HISTORIC AND DESIGN REVIEW COMMISSION

February 07, 2018

HDRC CASE NO: 2018-054
ADDRESS: 1021 N PALMETTO
LEGAL DESCRIPTION: NCB 1369 BLK 6 LOT N 46 FT OF 8 & 9 ARB A-1
ZONING: R-4 H
CITY COUNCIL DIST.: 2
DISTRICT: Dignowity Hill Historic District
APPLICANT: Ricardo McCullough
OWNER: Imagine Holdings
TYPE OF WORK: Construction of a 2-story residential structure
APPLICATION RECEIVED: January 19, 2018
60-DAY REVIEW: March 20, 2018
REQUEST:

The applicant is requesting final approval to construct a 2-story single family home on the vacant lot at 1021 N Palmetto.

ROOF TOP TERRACE PLAN
SCALE: 1/4" = 1'-0"

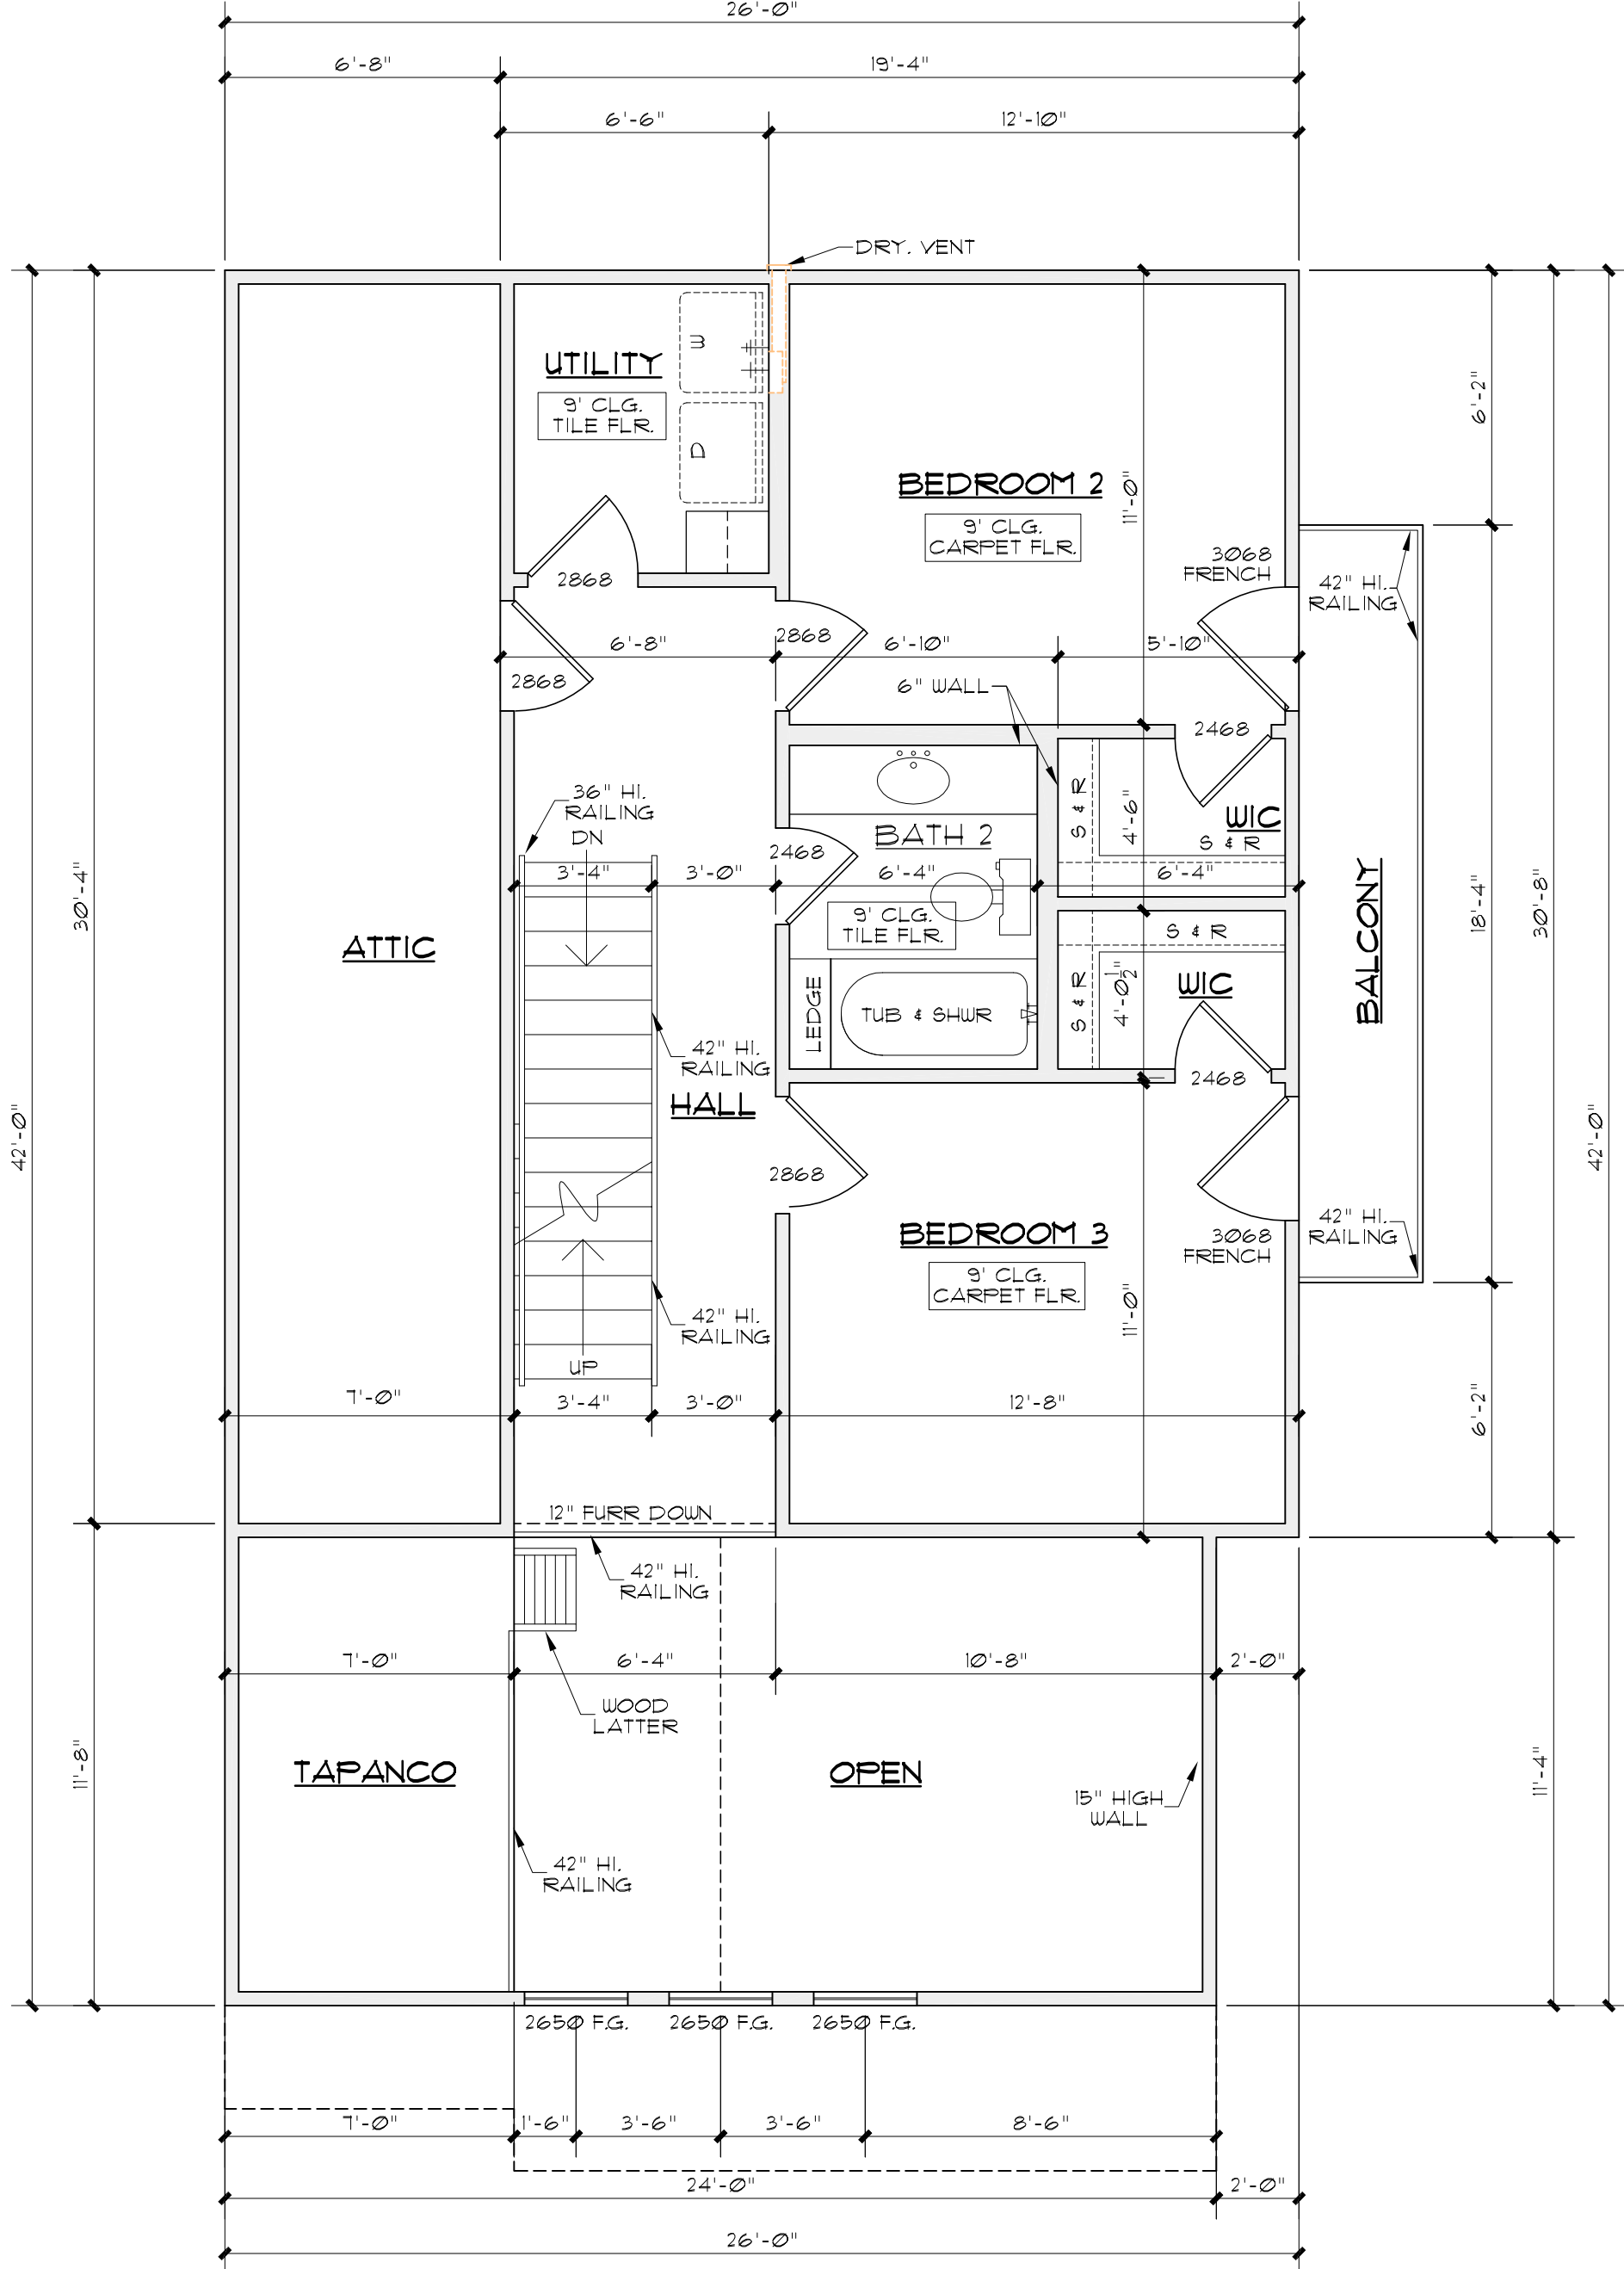
2. **That the applicant removes the proposed chimney roof element and proposes an alternative solution for access to the rooftop terrace as noted in finding i;** this stipulation has not been addressed in the current submittal.

- i. ROOF FORM – The applicant has proposed a gable roof form and a habitable flat rooftop terrace on the rear elevation. The proposal also includes a chimney-like element with a small gable to provide access to the rooftop terrace. The cross gable pitch is commonly found in the Dignowity Hill Historic District. Guideline 3.A.iv states that new metal roofs should be constructed in a similar fashion as historic metal roofs in the district. Staff finds the gable roof form and terrace condition generally consistent, but finds that the chimney element holds no precedent and is not appropriate. Staff finds that the standing standing seam metal roof should feature panels that are 18 to 21 inches wide, seams are 1 to 2 inches in height, and a crimped ridge seam.

- i. That the applicant reduces the floor plate height to reduce the overall height of the structure where feasible as noted in finding g.
- ii. That the applicant removes the proposed chimney roof element and proposes an alternative solution for access to the rooftop terrace as noted in findings g and i.

LEFT ELEVATION

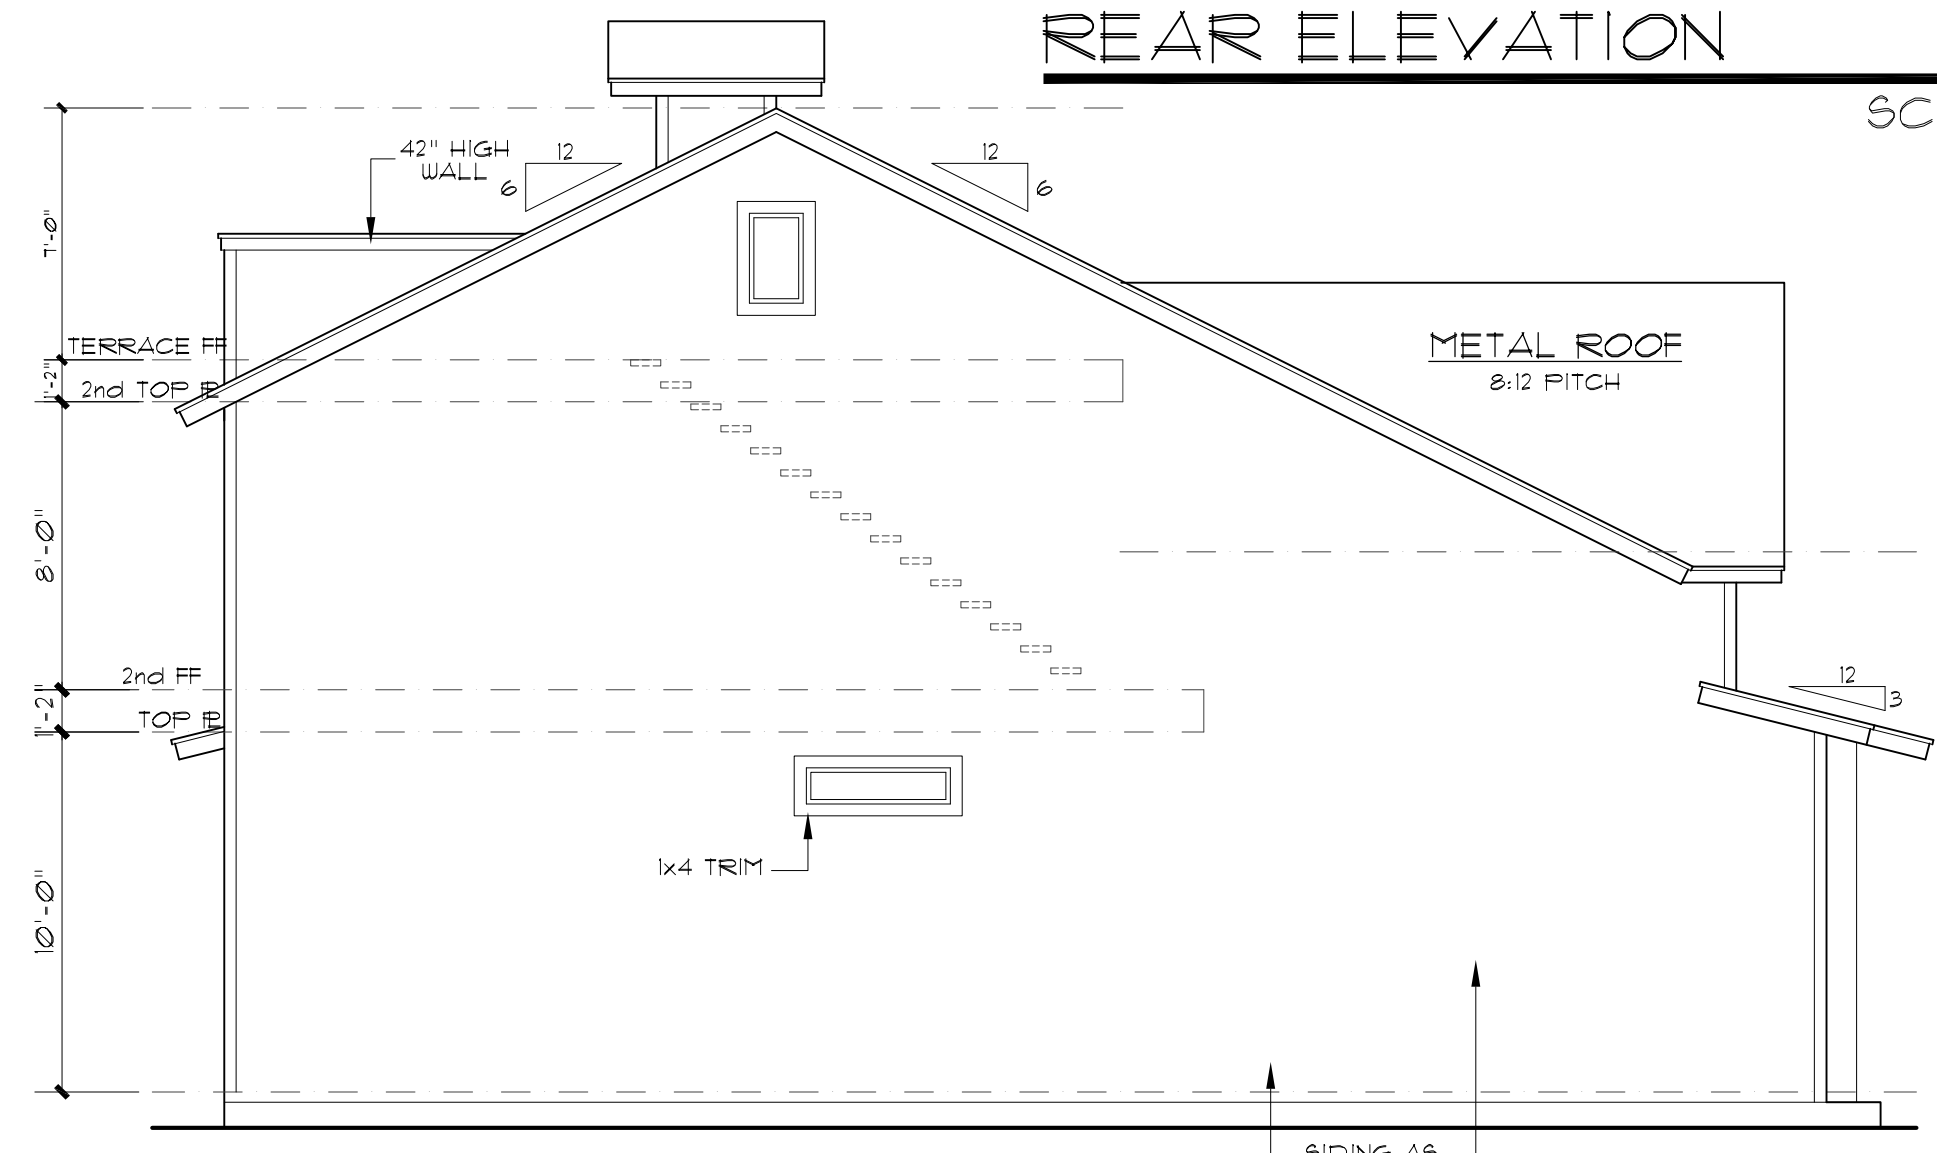
4. **That the applicant proposes windows on the left elevation that feature proportions and configurations that are more consistent with historic window patterns in the district as noted in finding j. Staff finds one over one windows to be appropriate and encourages the applicant to carry the window pattern of the three other elevations over to the left elevation for consistency;** this stipulation has not been met in the current submittal.

- j. WINDOW & DOOR OPENINGS: PROPORTIONS AND PLACEMENT – Per the Guidelines for New Construction 2.C.i., window and door openings with similar proportions of wall to window space as typical with nearby historic facades should be incorporated into new construction. The applicant has proposed several window openings that are consistent with historic precedents. However, staff finds that the left elevation features window sizes that are not consistent with the Guidelines, OHP Window Policy Document, or historic patterns in the district. Additionally, the paired windows do not feature a ganged condition. Staff finds that trim and framing details should be incorporated to be more consistent with window precedents in the district.

- iv. That the applicant proposes windows on the left elevation that feature proportions and configurations that are more consistent with historic window patterns in the district as noted in finding j. Staff finds one over one windows to be appropriate and encourages the applicant to carry the window pattern of the three other elevations over to the left elevation for consistency. All windows on the structure should feature architecturally appropriate inset, trim, and sill detail. The applicant should incorporate a true ganged condition for paired windows as noted in finding j.

FRONT ELEVATION

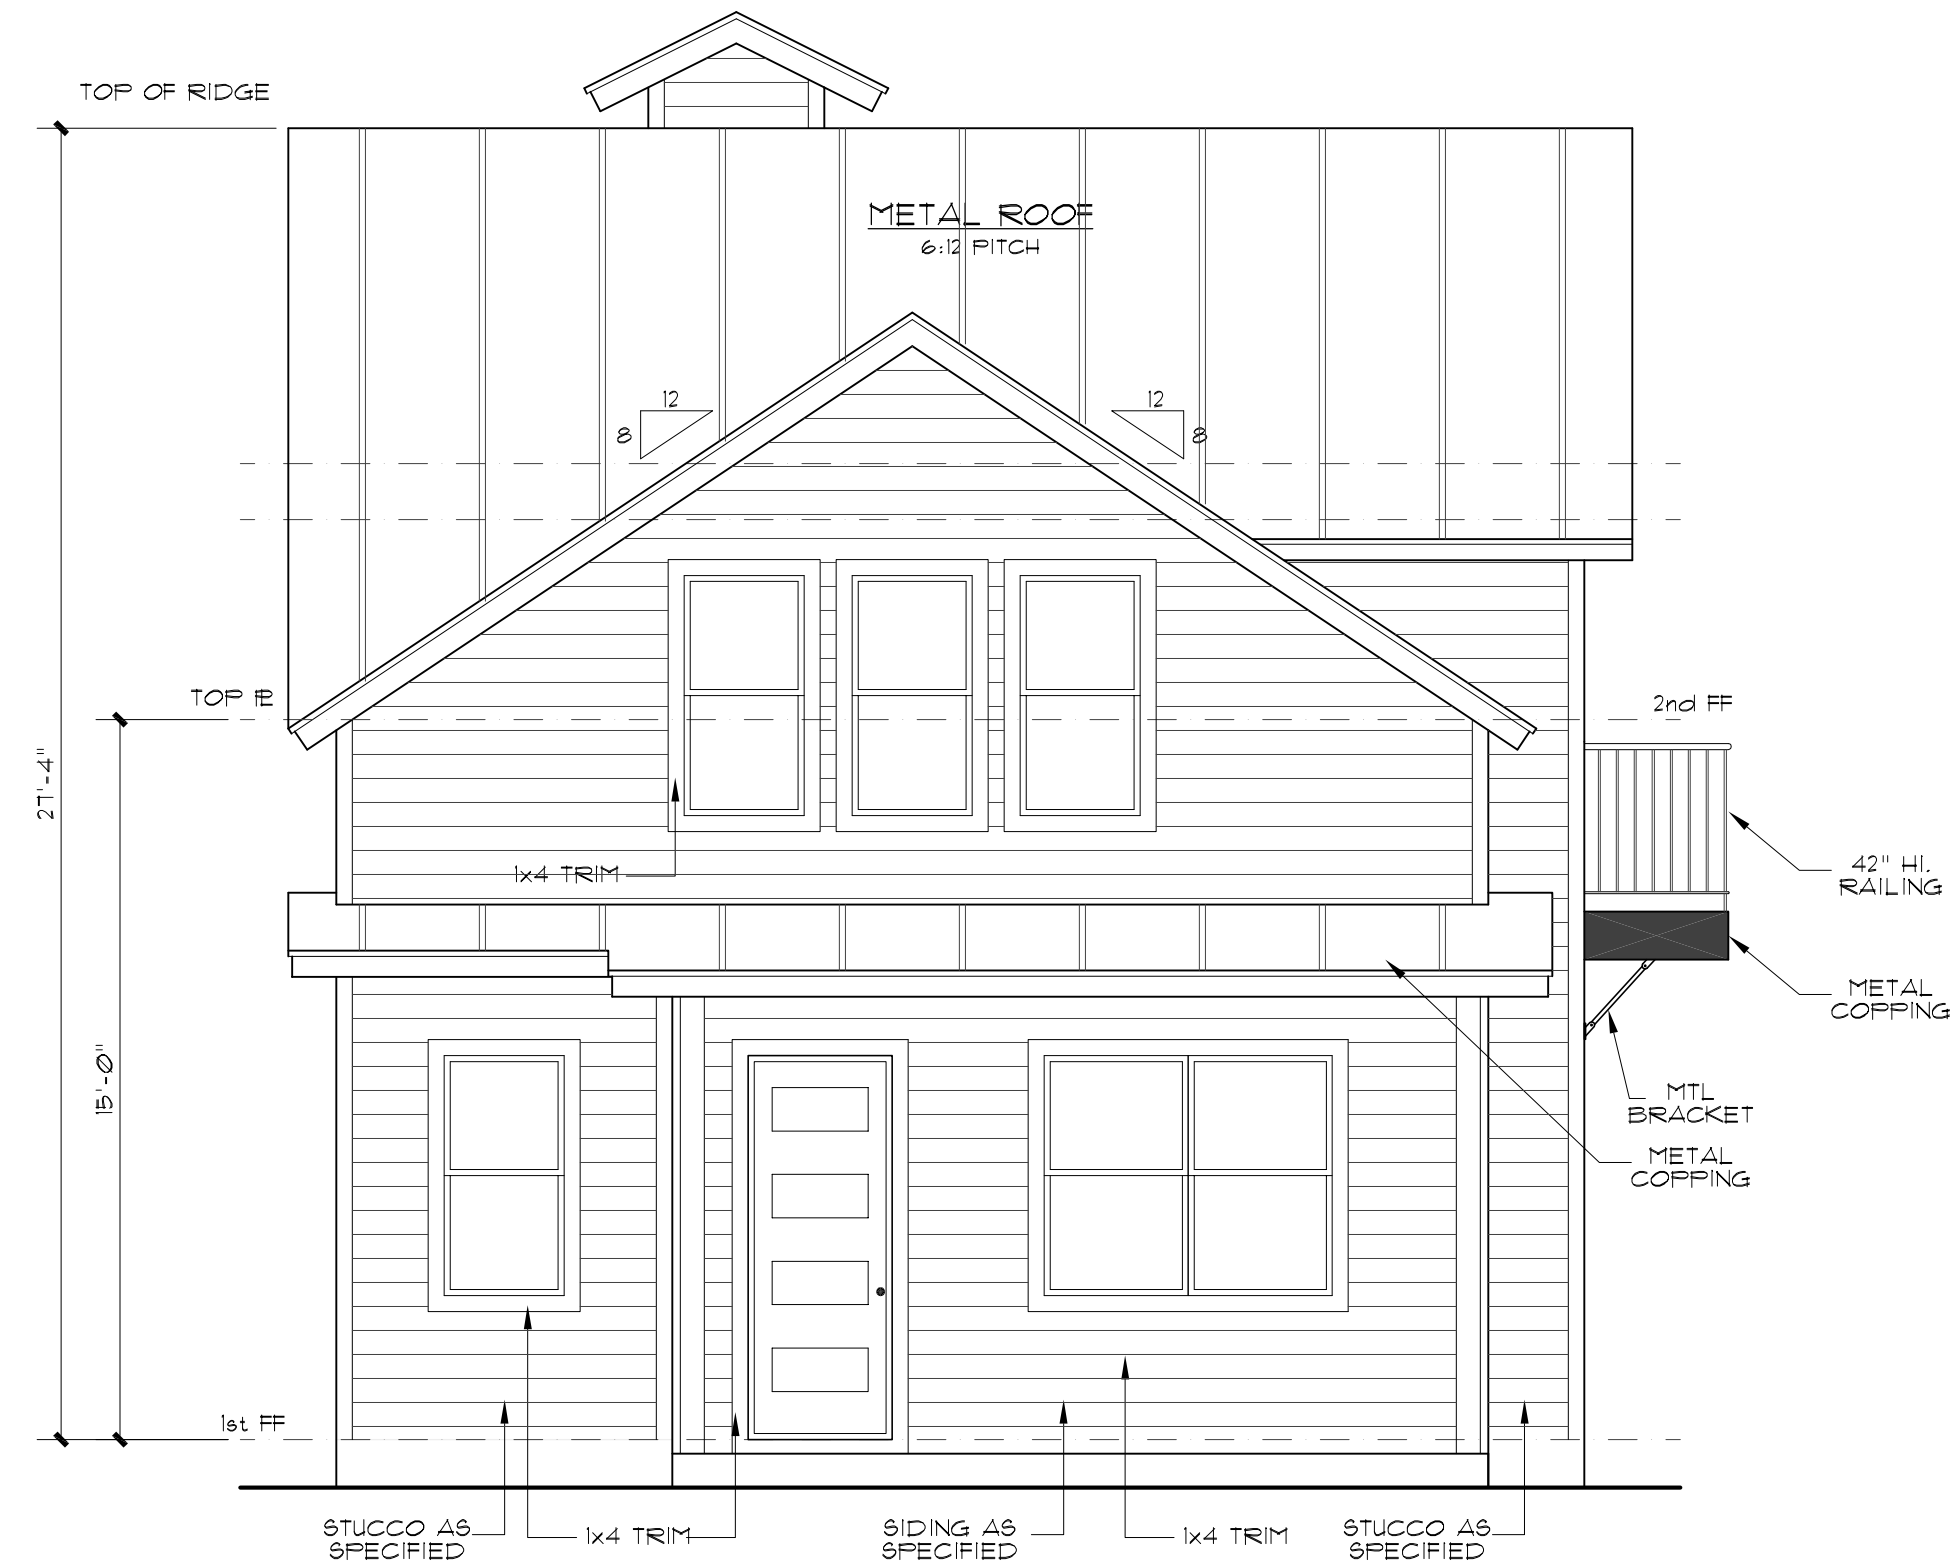
3. **That the applicant explores a front porch design that creates a true porch condition. The porch should extend towards the street and feature more depth to be more consistent with the porch depths and configurations of the Dignowity Hill Historic District as noted in finding f. The final porch design of the rear elevation should respond to the changes made on the front porch and share similar design elements;** this stipulation has not been fully addressed in the current submittal.

- f. ENTRANCES: PORCH – The applicant has proposed a front entrance that projects approximately four feet from the primary setback of the front façade. Historic structures throughout the Dignowity Hill Historic District feature distinct porches that engage the pedestrian streetscape and feature numerous widths, depths and roof styles. The front and rear porch will both feature a standing seam sloped metal roof. Staff finds that the general porch roof form and condition may be appropriate for the district, but finds that the submitted drawings contain several inconsistencies in terms of porch column placement and depth regarding the rear porch.

- iii. That the applicant designs the front and rear porches that respond to each other and share similar design elements. The applicant must submit all porch details, including column dimensions and roof overhang depth, for consideration for final approval.
